COUNTY OF MONROE
DEPARTMENT OF TRANSPORTATION
ADDENDUM NO. 1 TO THE
CONSTRUCTION SPECIFICATIONS AND RELATED DOCUMENTS
FOR
IMPROVEMENTS TO DORSEY ROAD

NYS DOT PIN 4753.79
Capital Improvement Project No. 1445

February 3, 2011

ADDENDUM NO. 1
To the Contract Documents for the
IMPROVEMENTS TO DORSEY ROAD
MONROE COUNTY, NEW YORK

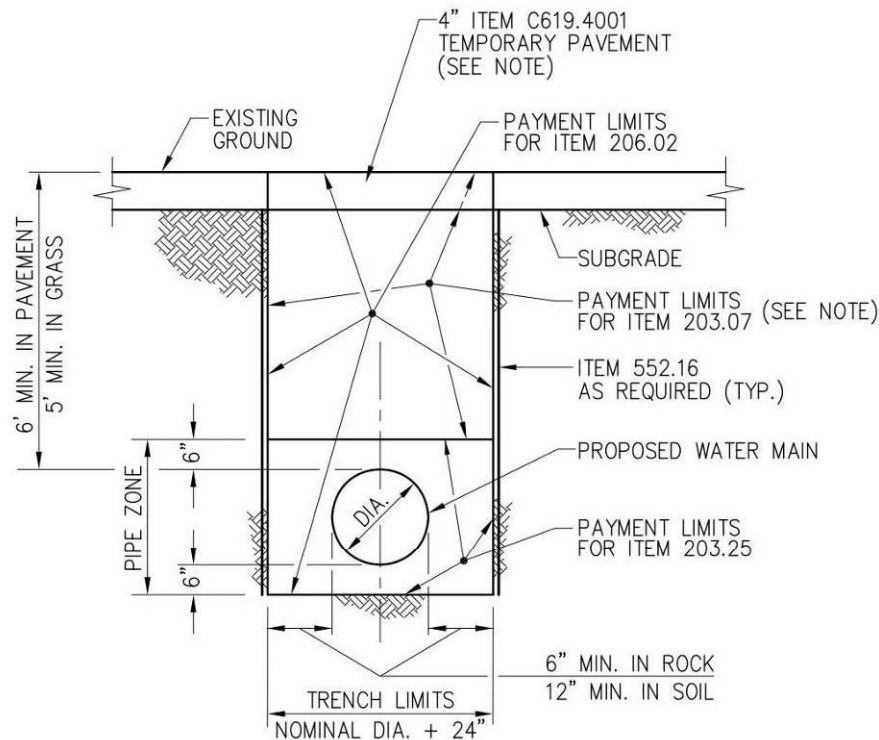
4. Modification to Milling Table on Sheet 36 (Drawing CT-5). The milling between D 41+00 and D 42+46.2 should be removed from the table. This area is full depth reconstruction as shown on Sheet 44 (Drawing PL-7). The milling table inadvertently identified milling in an area that should have been full depth reconstruction.

Please refer to the following corrected table:

WATER MAIN TRENCH

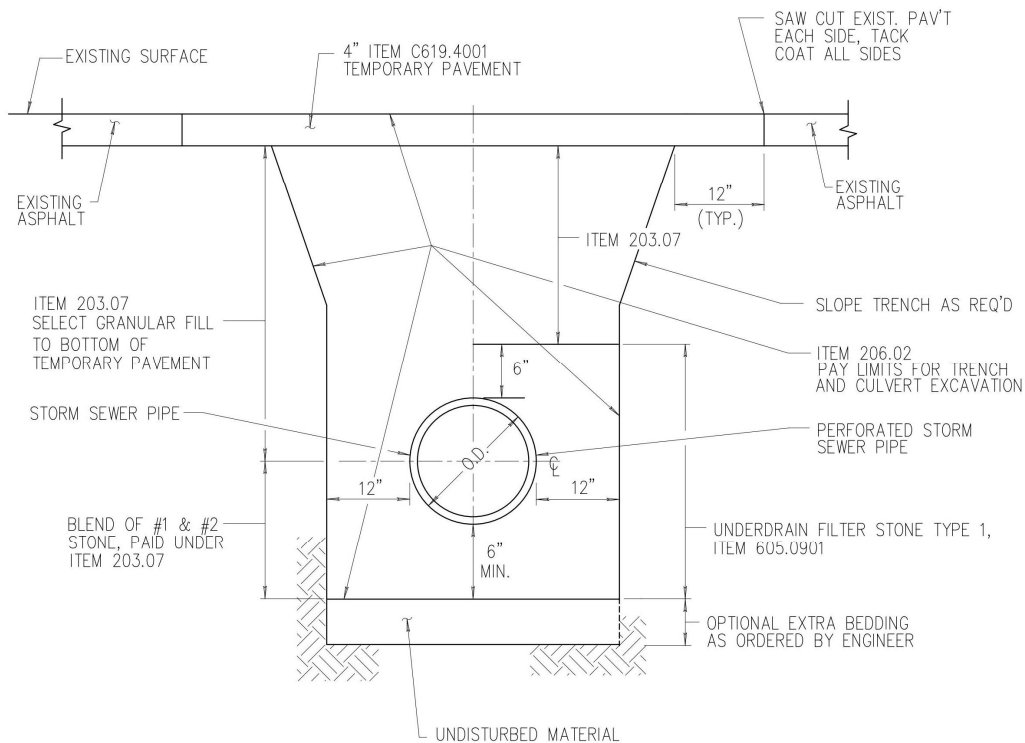
11. Modification of Water Main Trench detail on Sheet 28 (Drawing WD-2). The upper pay limit of Item 206.02 shall be existing ground. Backfill will be made with Item 203.07 to the bottom of the temporary pavement (in pavement areas) or backfill with native material in grass areas. Payment for native material shall be included in the bid for Item 206.02.

BACKFILL WITH ITEM 203.07 — SELECT FILL TO THE BOTTOM OF TEMPORARY PAVEMENT IN PAVEMENT AREAS.

BACKFILL WITH SUITABLE NATIVE SOIL IN GRASS/SIDEWALK AREAS, COST INCLUDED IN ITEM 206.02.

COMPACT IN A MAXIMUM OF 6" LIFTS
